**MANDATORY BULLETIN**  
**No BE-057/SZD-50-3/2006 „PUCHACZ”**

DESIGNATION-TYPE/MODEL: SZD-50-3 “PUCHACZ”

CONCERNS: Introduction of an extra pull rod segment in the rudder control system

Fig. 1

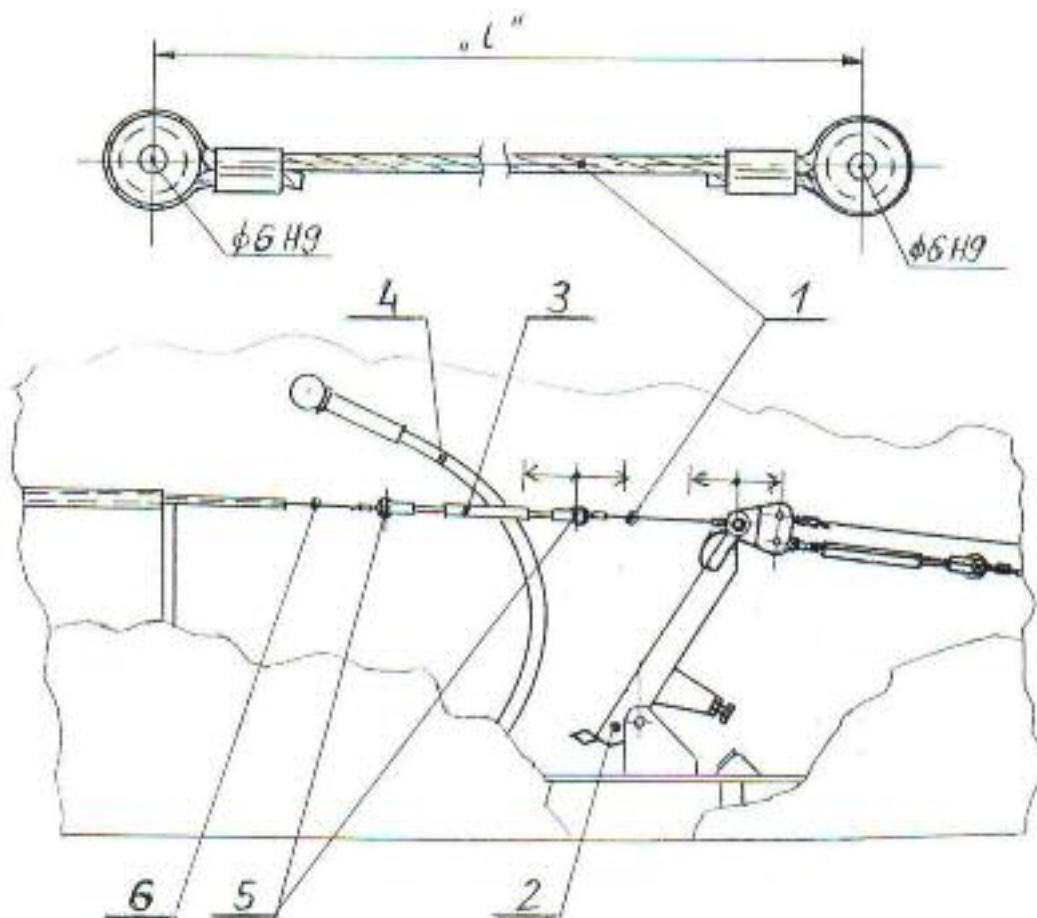
Herewith, an extra segment of pull rod ((1) – Fig (1), of approx 140mm length “I”, is being introduced between the rear pedals (2) and turnbuckle (3) of pull rod connected to a rudder.

This modification is aimed at elimination of the lateral load component applied at turnbuckle terminal by {pilot} foot. In several instances this has brought to fatigue failure and break of the terminal at the site of transition into eyelet.

- 4.1 , On the gliders, where the eyelet terminal of the turnbuckle is connected directly to the pedals, the terminals are to be disconnected from the left-, and right pedal and scrapped. The eyelet type terminals are to be replaced with fork type with the same thread (right/left hand).

- 4.2 Between the pedals (2) and turnbuckle (3), install a short pull rod (1) of aircraft type steel cable with 3 mm diameter core and approx 140mm length “I”. The length is to be adjusted so that the shield of the wheel brake pull rod (4), on a left side board, remains between the turnbuckle lateral screws (5) over the whole travel of turnbuckle (fore-aft).

- 4.3 Shorten the pull rods (6) connecting a rudder with rudder by a value obtained by adding the length of extra pull rod with a difference between the eyelet- and fork terminal lengths.

- 4.4 The M4 nuts, securing the connection between the pull rod and pedal are to be of a castellated, thin type with 1 mm diameter cotter pin.
